**Re: Grading and Drainage Plan for Marberry Development Lots 5 & 6, Loma Linda
Engineer's Stamp Dated 1-2-02, (L16/D34A)**

**RE: Grading and Drainage Plan for Marberry Development Lots 5 & 6, Loma Linda
(L-16/ D34A), Engineer's stamp dated July 26, 2001. (L-16)**

**RE: MARBERRY DEVELOPMENT LOTS 5 & 6, LOMA LINDA
SUBDIVISION FILE NO. L16/D34A**

RE: Drainage Complaint for Marberry Development Lots 5&6, LOMA Linda (L16-D34A)

CITY OF ALBUQUERQUE, BERNALILLO COUNTY		NEW MEXICO	
LOTS 5 & 6, BLOCK SA LOMA LINDA SUBDIVISION			
HARBERRY DEVELOPMENT			
McDowell Engineering Inc.			
Designed JSM	Drawn STJ	Checked JSM	Sheet 1 of 1
Date MAR 2001	Date JUL 2001

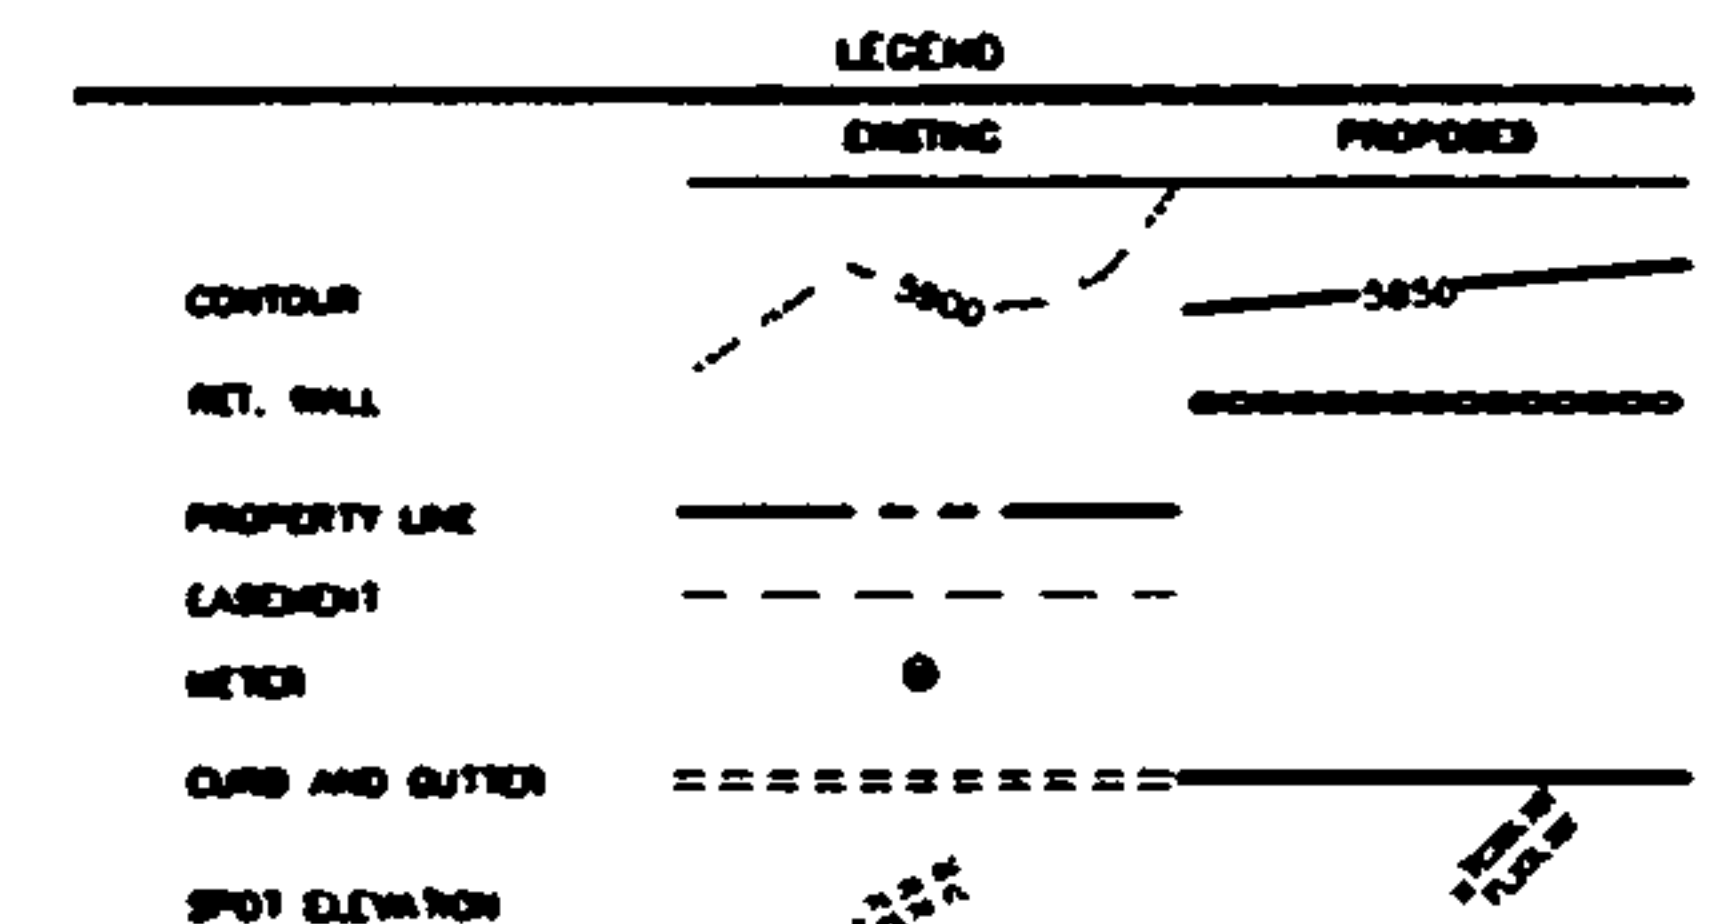
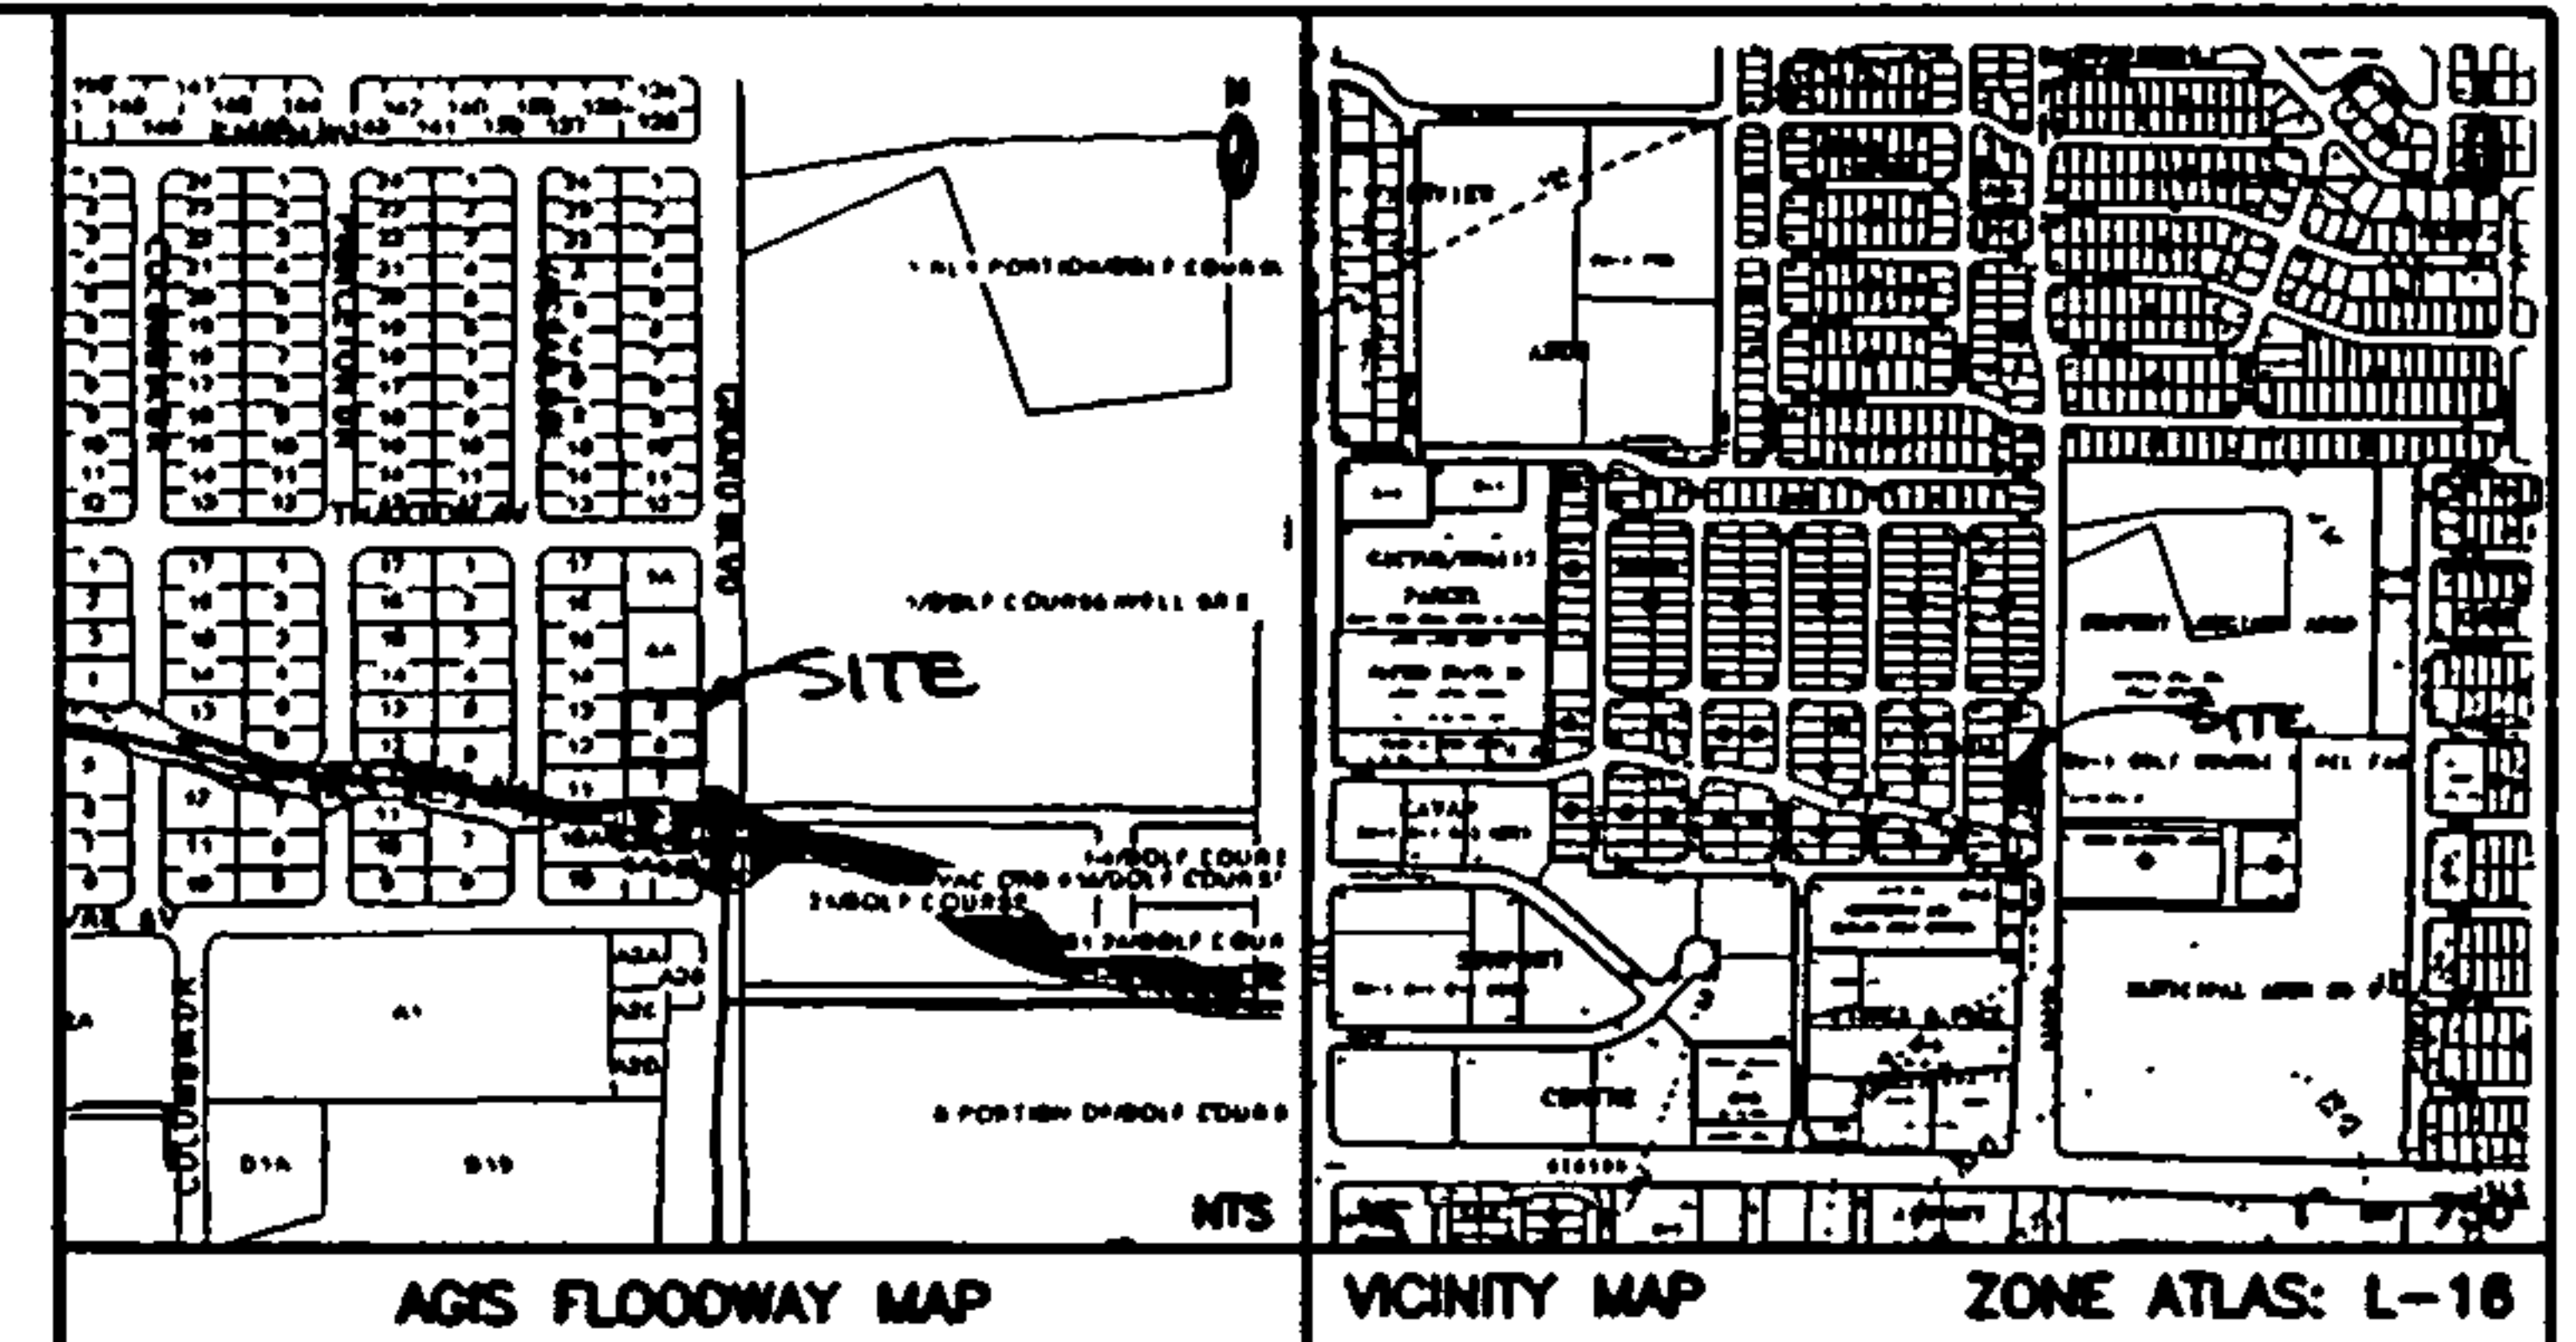
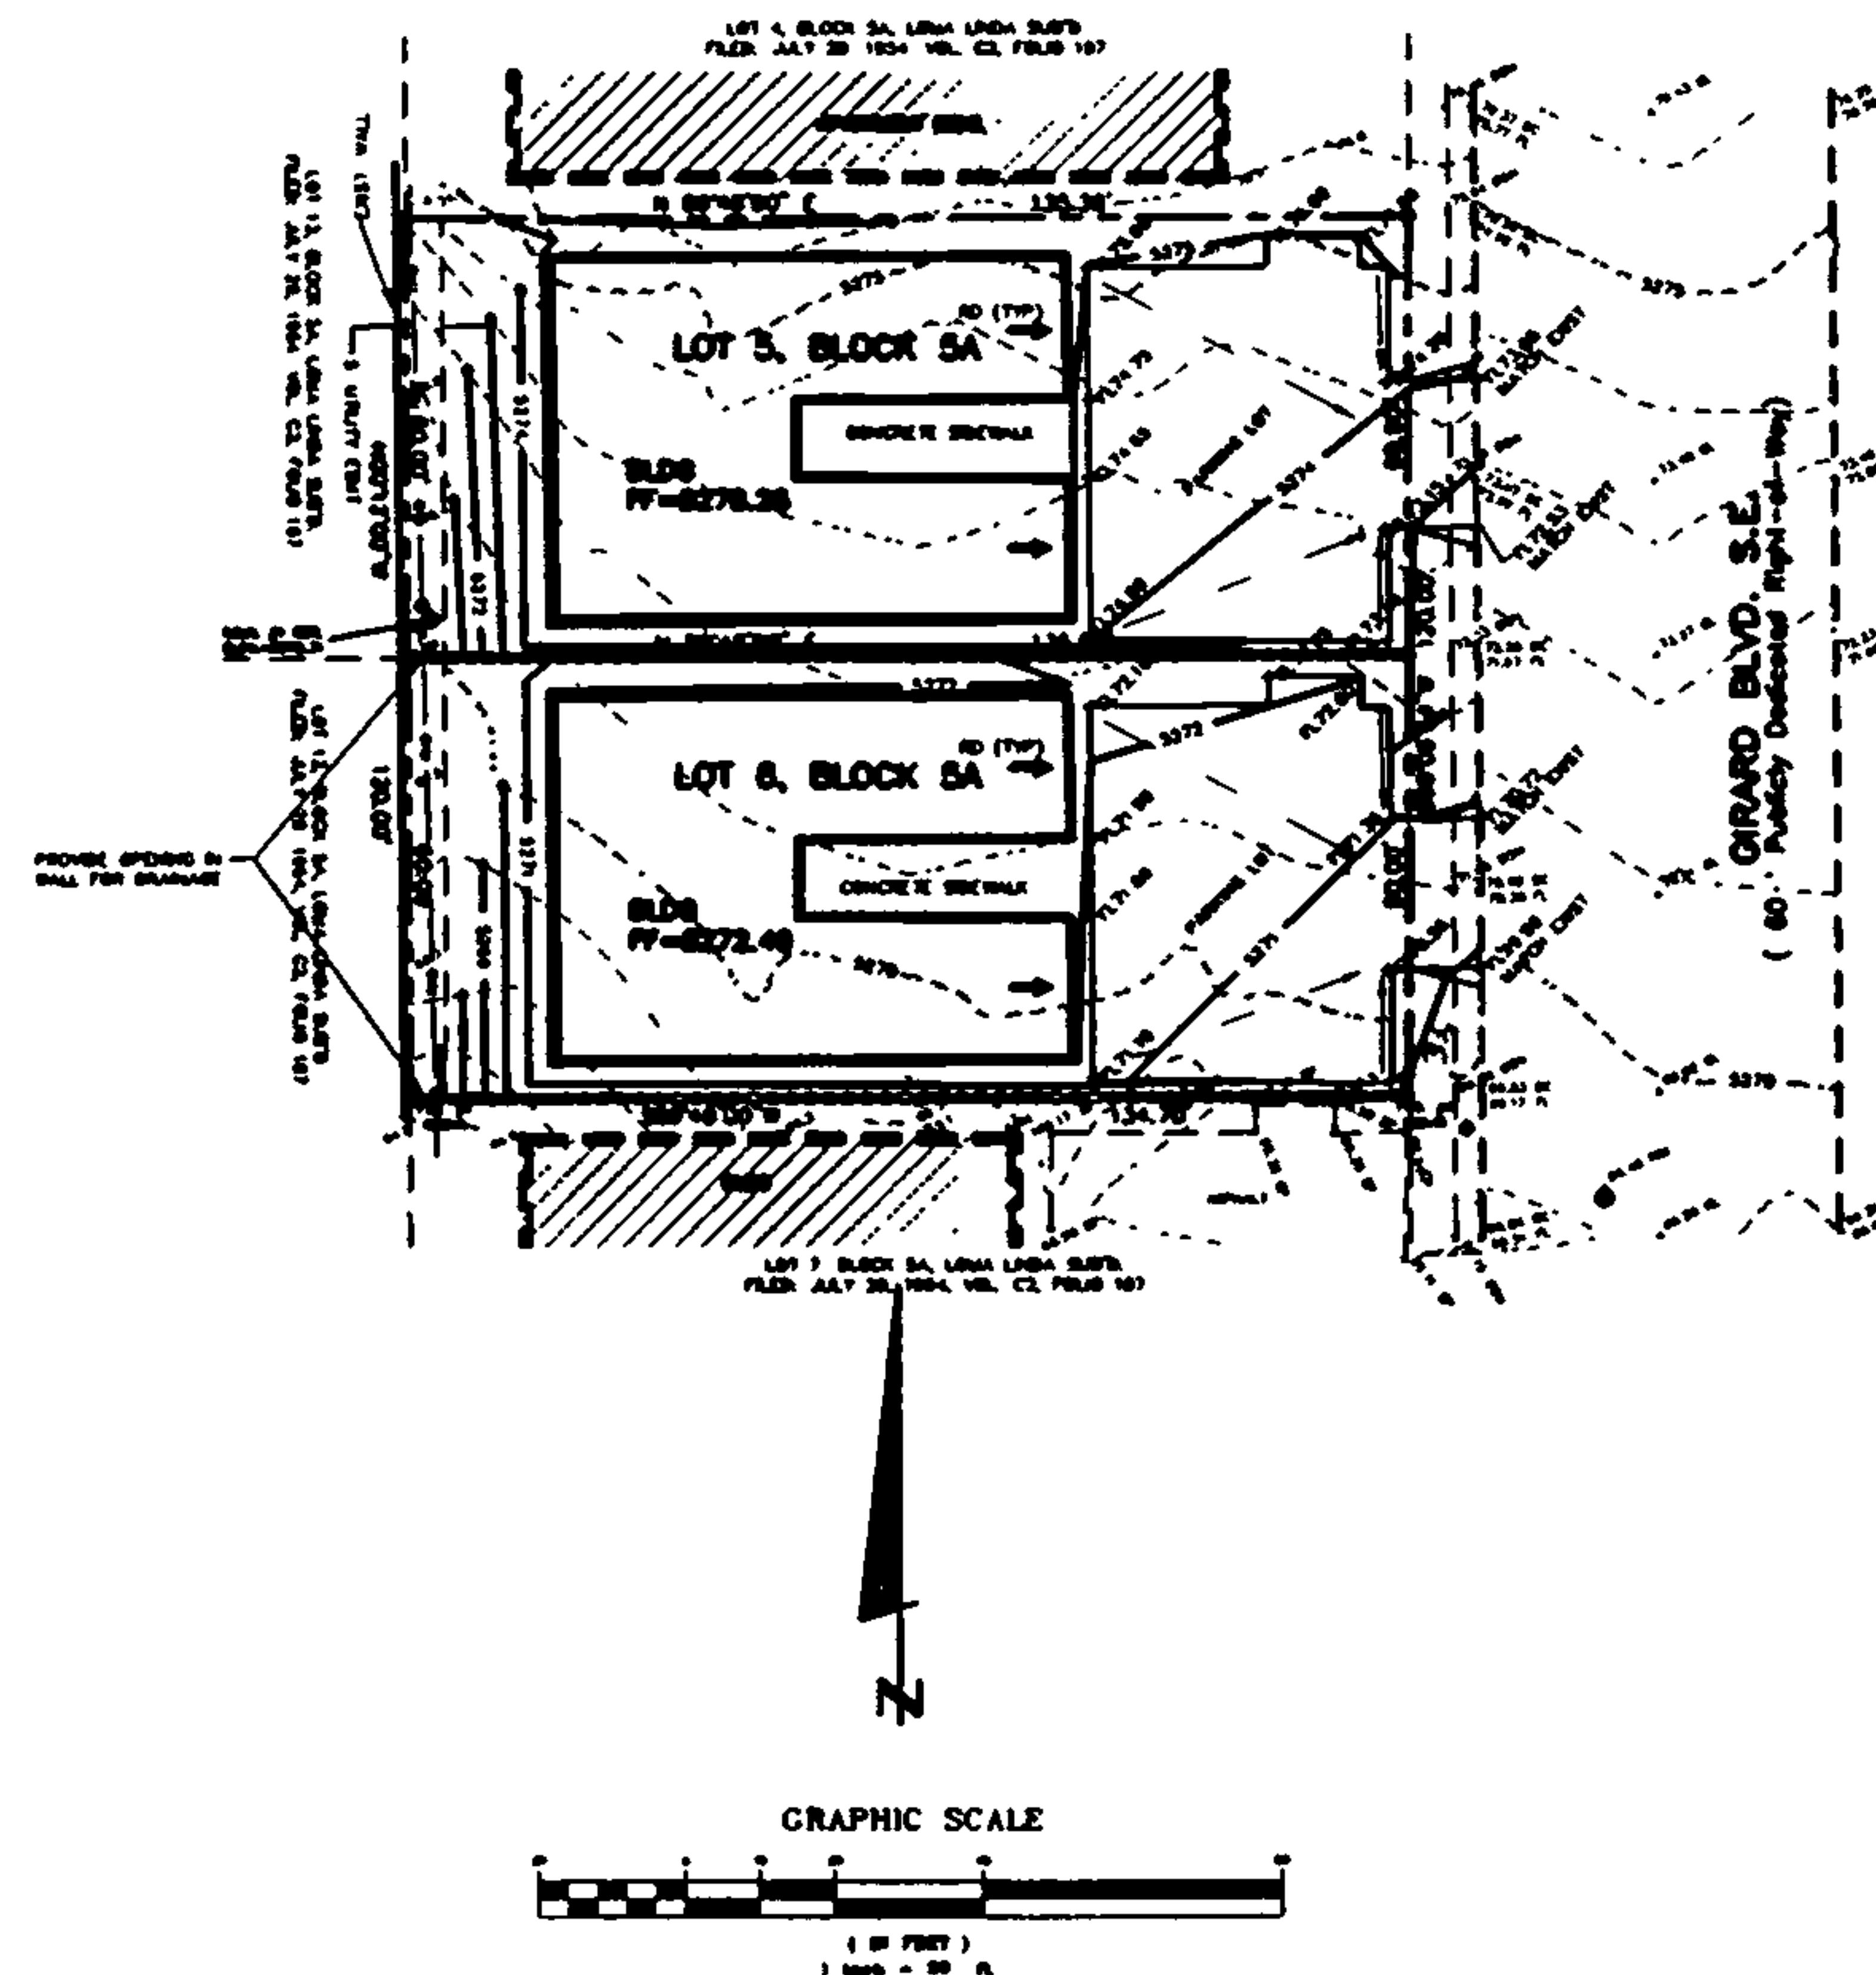
- Please show the dimensions of the "opening in wall" called out on the plan.
- Please quantify off-site flows from Lot 4.
- There is an existing drainage easement north and south of all lots indicated on the plan, please identify on plan and submit drainage easement agreement.

- As a condition of approval, please show the dimensions of the "opening in wall" called out on the plan, per our phone conversation today.

1. Please show the grades along the retaining wall on both sides.
2. Indicate the elevation of the top of wall.
3. Indicate which part of the wall is a retaining wall and which part is a garden wall.
4. Was a retaining wall permit obtained for this retaining wall in the past?
5. Is this retaining wall capable of supporting the existing and proposed grades?

Your original drawings should have contained the above information. Also, please submit a detail on how this runoff will be released to the south and if downstream lots can safely carry this runoff.

- The area and capacity of the turned blocks have been called out on the plan.
- The offsite flow for Lot 4 is 0.77 cfs. Calculations are attached.
- The existing 10' drainage easement along the west property line for the north and south lots has been indicated on the plan. A copy of the portion of the plat showing the easement is attached.
